PUR-1449 ADDENDUMNO. 2 INVITATION TO BID

COURTHOUSE AND CLERK'S OFFICE BALLISTIC GLASS

ADDENDUM NO. 2 Courthouse and Clerk's Office Ballistic Glass PUR-1449

Above Ceiling Photo – Land Records Counter

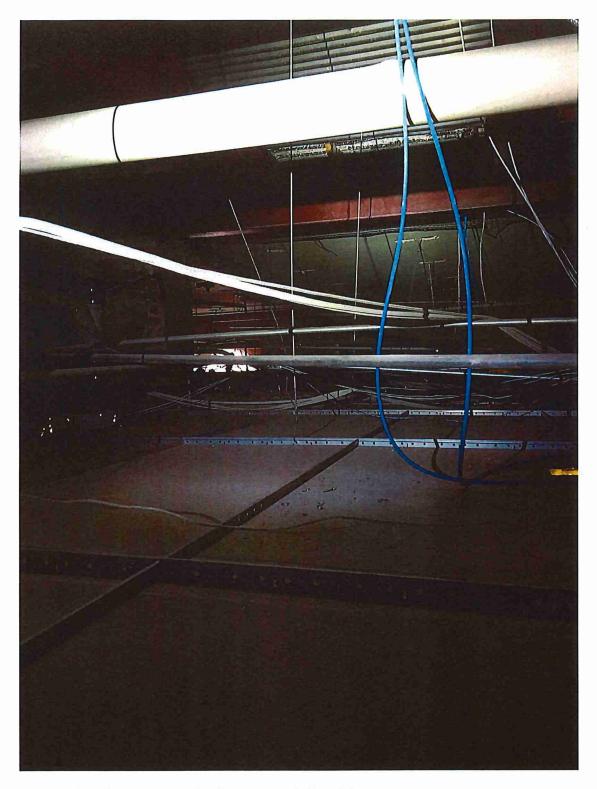
ITEM NO. 2: *Inquiry*: Are there any obstruction above the false ceiling to the third floor above where the ballistic glass, walls, and door will be installed (particularly above the door area)?

<u>Response</u>: See attached photos of the above ceiling areas.
